SERVICE BULLETIN

REFERENCE BODY
NUMBER 018
DATE 05-05-89
MODEL FJ6#

WINDSHIELD WIPER LINKAGE RODS

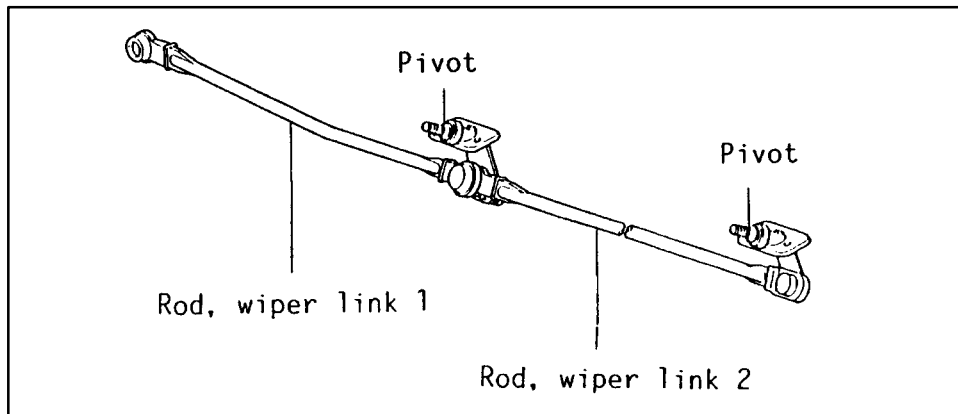
To improve the serviceability of the windshield wiper linkage assembly, the two rods in the wiper linkage are now available as separate replacement parts (see illustration).

Note: The rod does not include the pivot.

Rod, wiper link 1; connected from wiper motor to pivot.
Rod, wiper link 2; connected between two pivots.

New and previous parts are completely interchangeable.
